42 HONEYSUCKLE DRIVE COTTAGE CREEK PRECINCT NEWCASTLE

NEWCASTLE CITY COUNCIL
DEVELOPMENT APPLICATION

ARCHITECTURAL DESIGN RESPONSES

MAY 2018
REV B

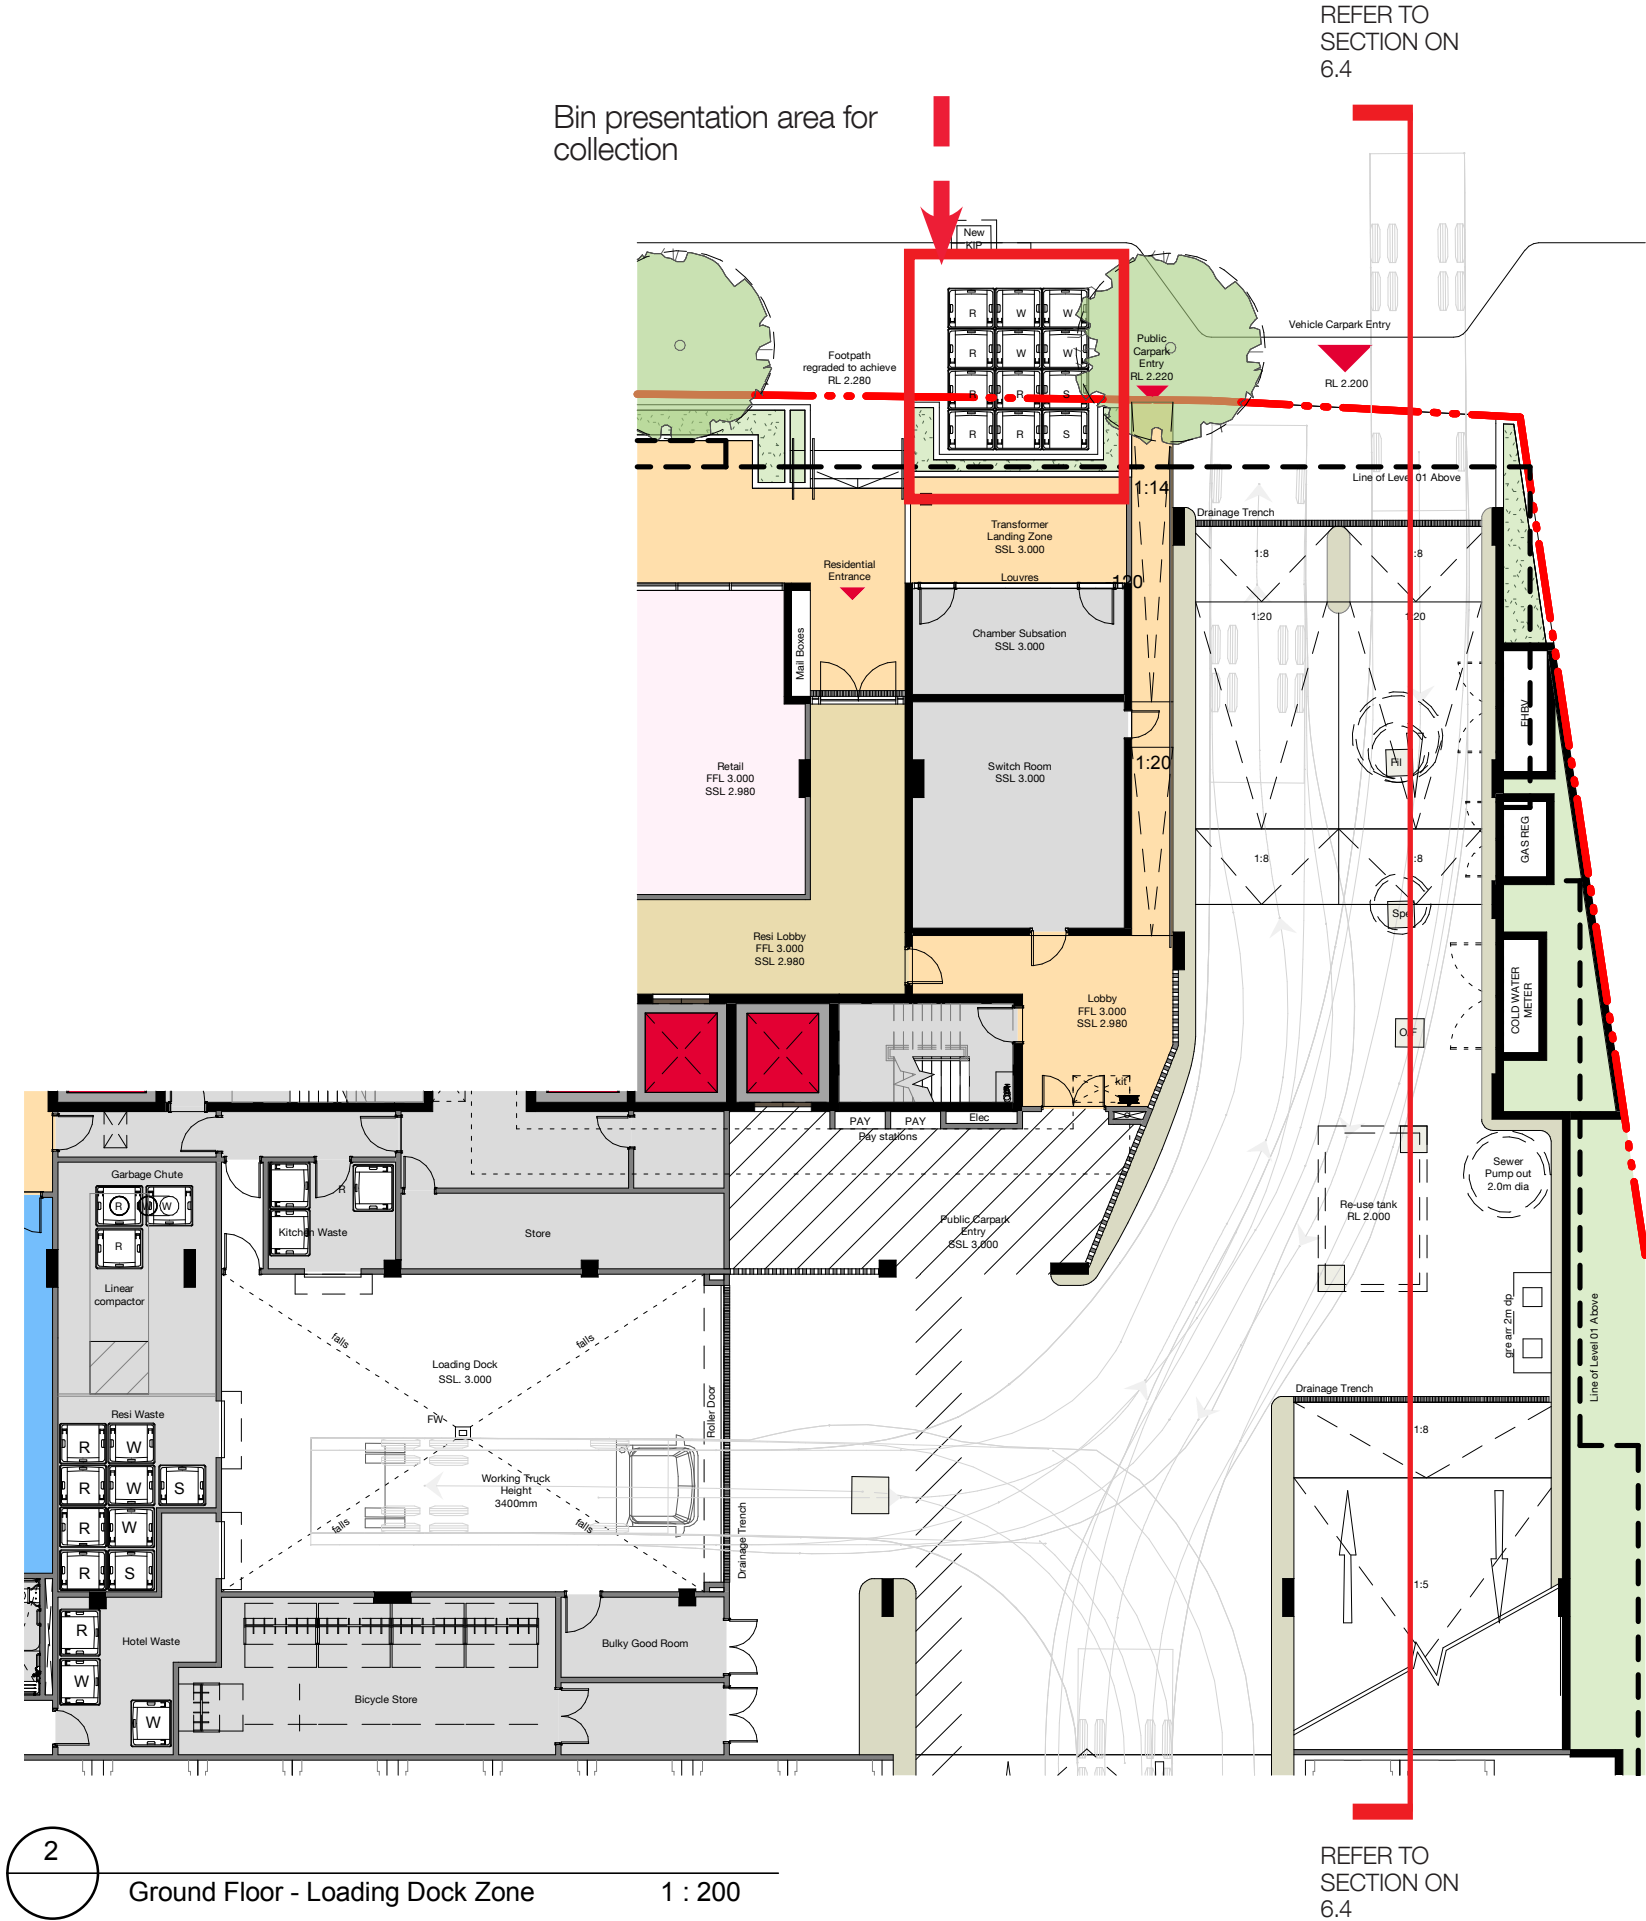
The submitted Waste Management Plan suggests that the traffic engineer should confirm that waste collection vehicles can enter and exit in a forward direction

The waste truck can enter and exit in a forward direction. Refer to plan illustrating the 3 point turn into the loading dock.

6.1 CAR PARK ENTRY SECTION:

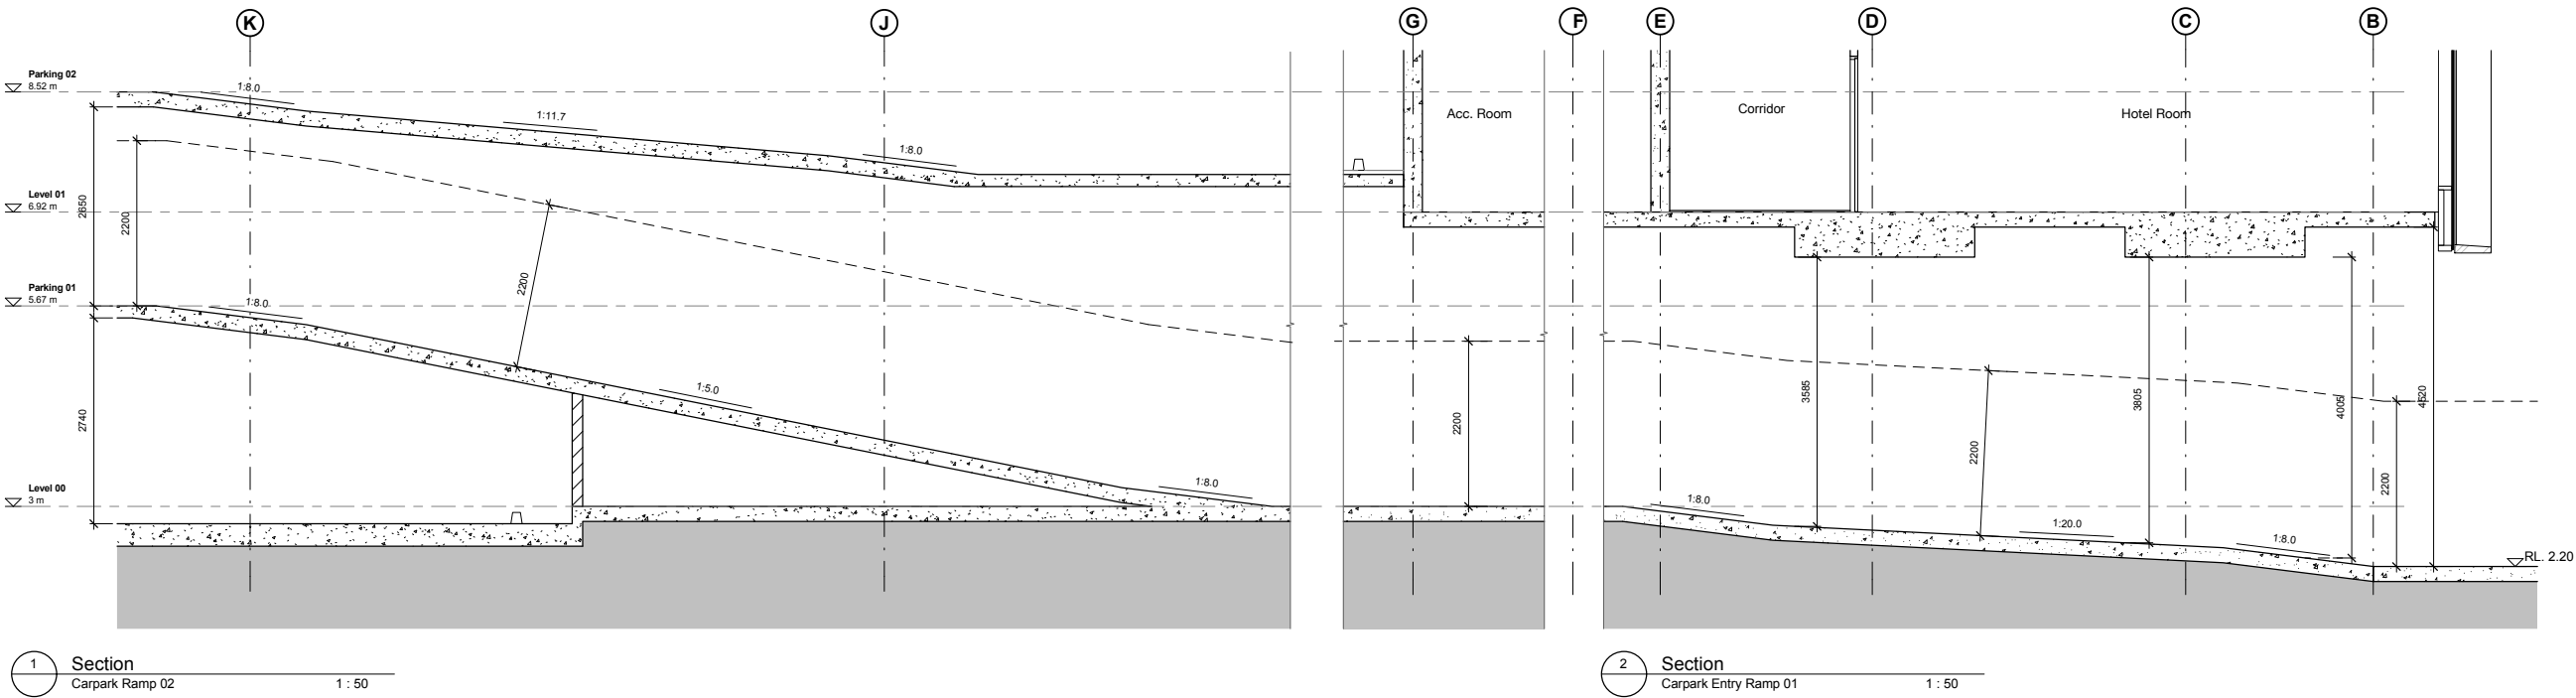
During the meeting with Council on 19.04.2018 an additional section through the carpark entry ramp was asked for.

It can be seen that the lowest point over the entry ramp is at 3.5m the loading truck require a working height of 3.4m.
